RE: Case 18-02P, Final Development Plan & Construction Drawings for Wynstead Section 5 A & B

On the agenda for March 6th meeting is Case #18-02P, an application for approval of the Final Development Plan & Construction Drawings (FDP) Wynstead Section 5 Phases A & B (the “Property”) submitted by Grand Communities, LTD (aka Fischer Homes) (the “Owner”).

Attached are our comments after reviewing the Wynstead Subdivision Section 5, Phases A & B subdivision plans, the storm calcs for the roadway storm sewer, and the construction estimate that were submitted to Choice One on 2/5/18. Choice One recommends that the plans and supporting documentation be resubmitted after revisions are made. An electronic resubmission of the revised items would be acceptable to Choice One.

GRADING & EROSION CONTROL PLAN

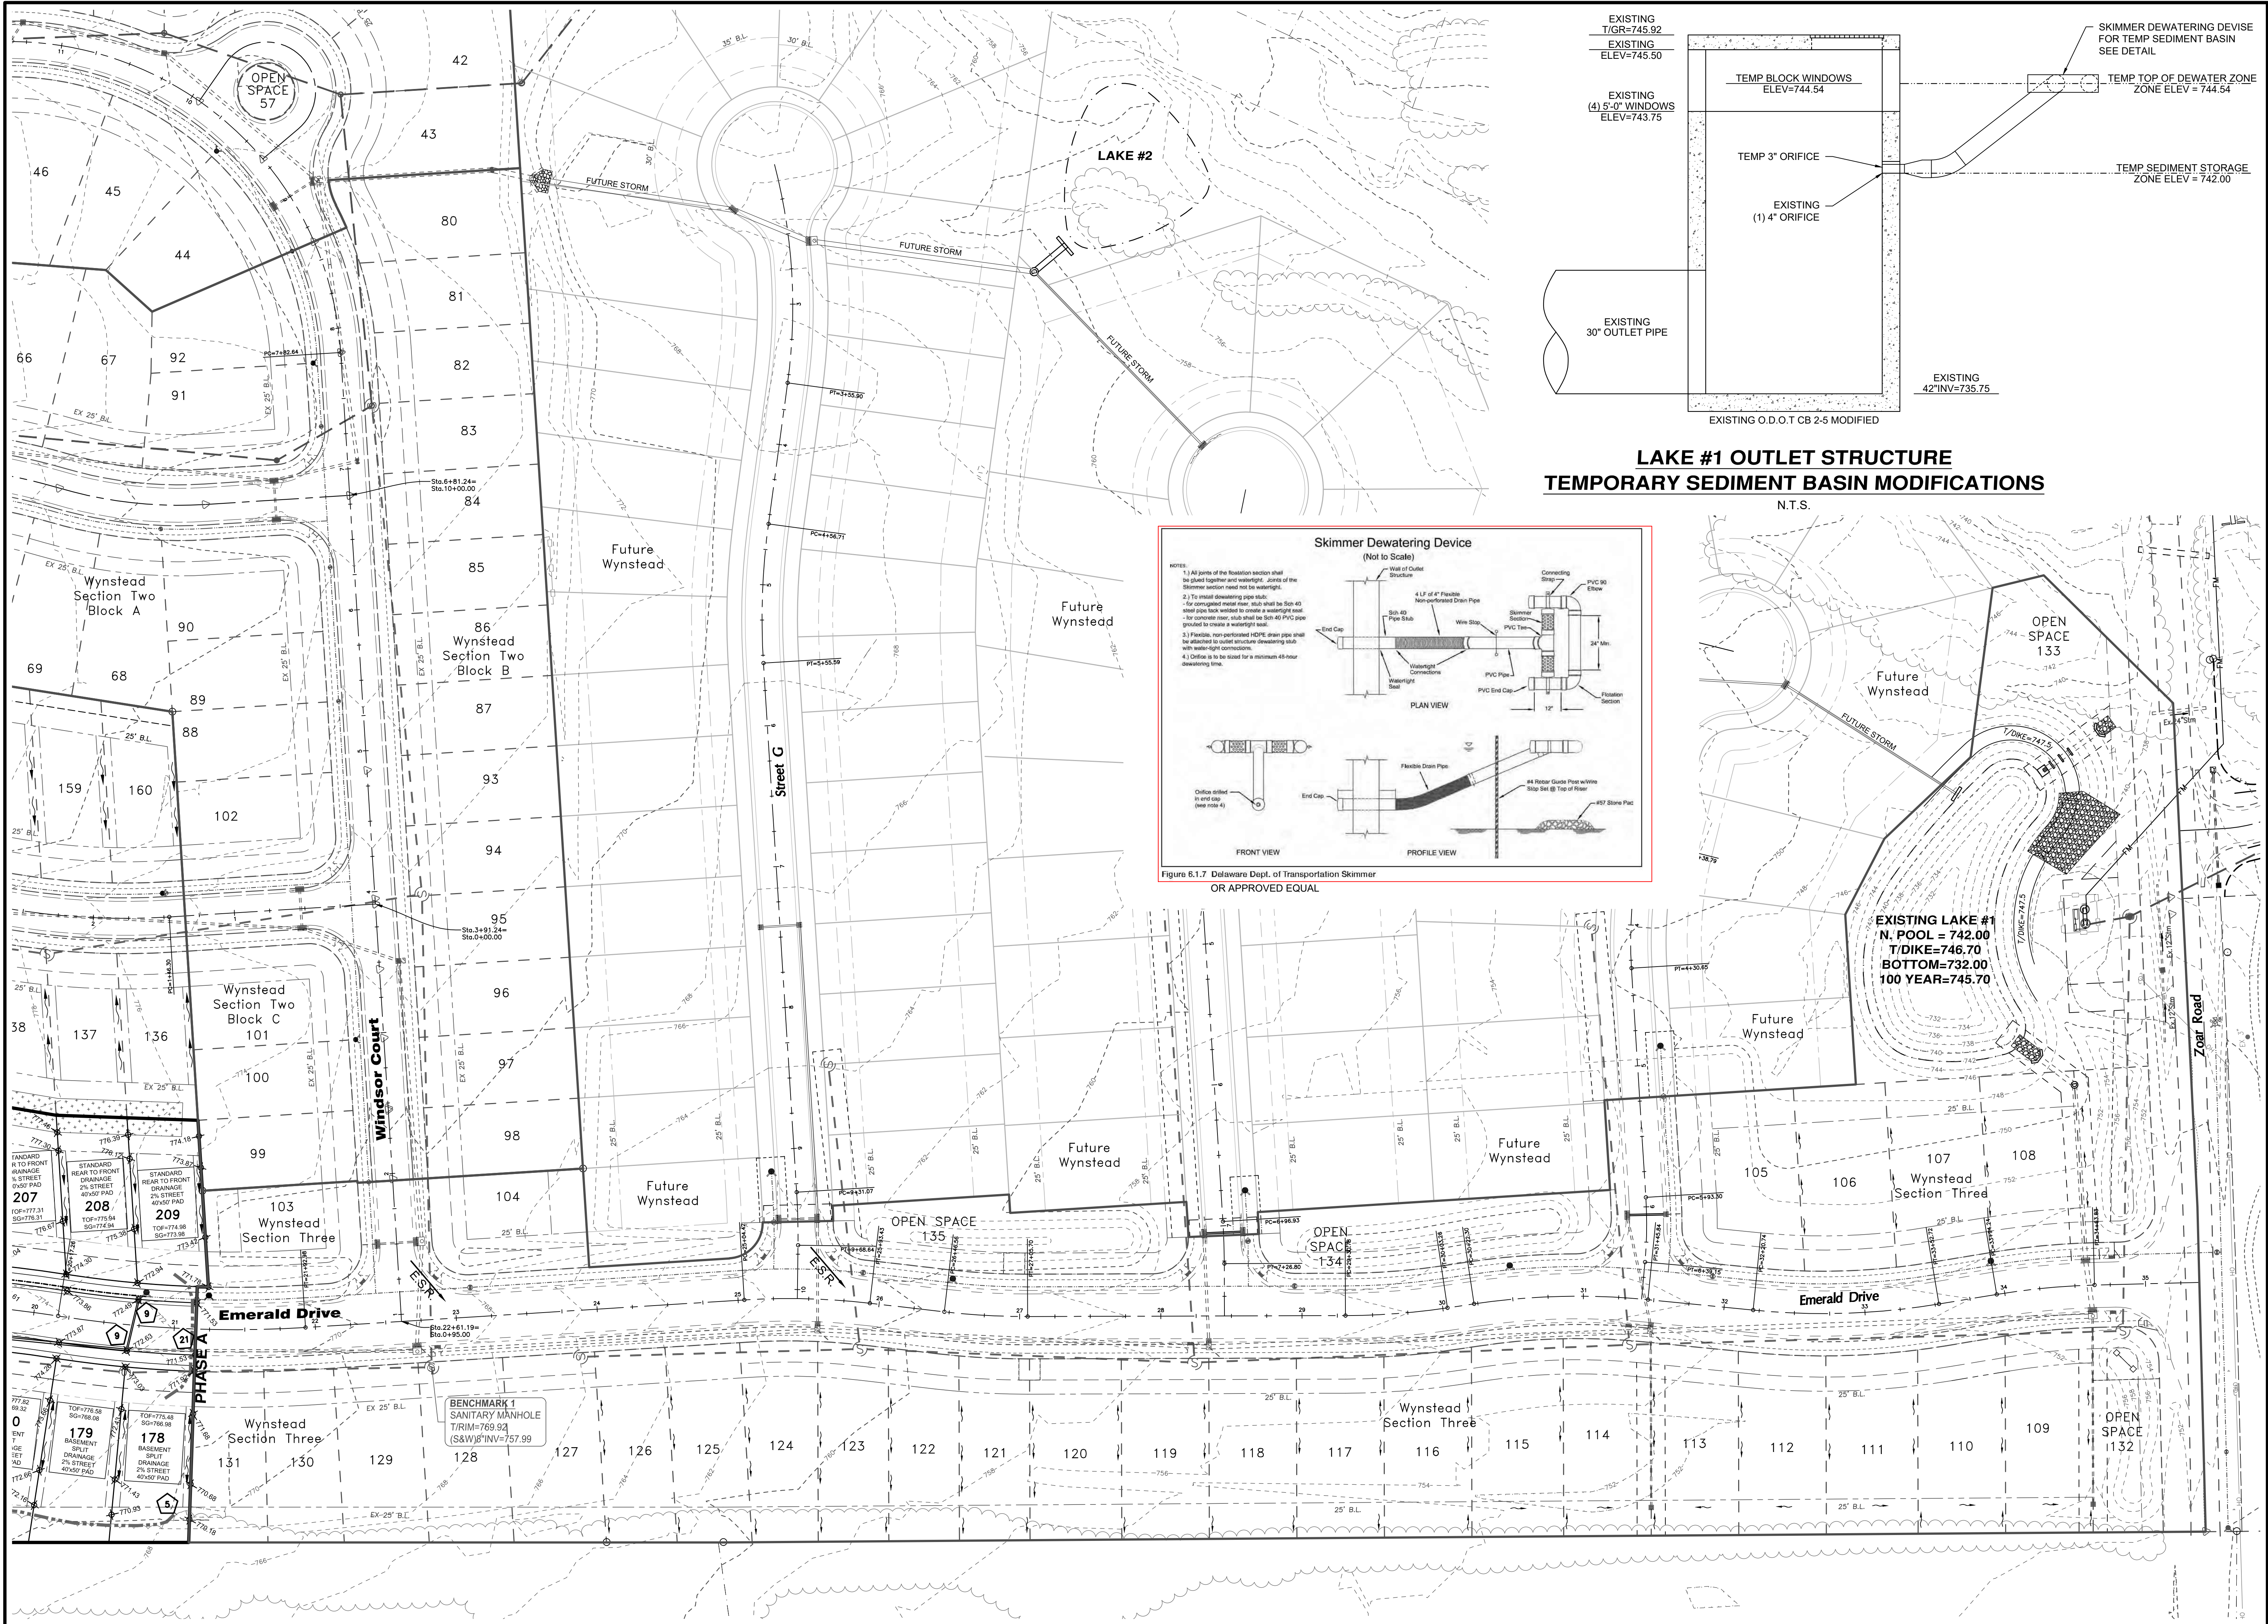
- Erosion and sediment control plan.
 - The plan is lacking in perimeter controls. There are areas of disturbed earth that would run off site without a control in place to first filter any sediment laden water. The south and east lines are particularly exposed.
 - Provide calculations for the sediment basin (Lake #1 & Lake #2) being used during construction of this section. Sediment basin construction must comply with the standards in the latest edition of the Rainwater and Land Development Manual.
- Please submit a Storm Water Pollution Prevention Plan (SWP3) in compliance with the Ohio EPA Checklist found at http://www.epa.ohio.gov/portals/35/storm/CGP_SWP3_Checklist.pdf

Item	Revision Description	Date	Drawn	Chk
1	REVISED PER SOUTH LEBANON & WARREN COUNTY W & S COMMENTS	03-07-17	GJK
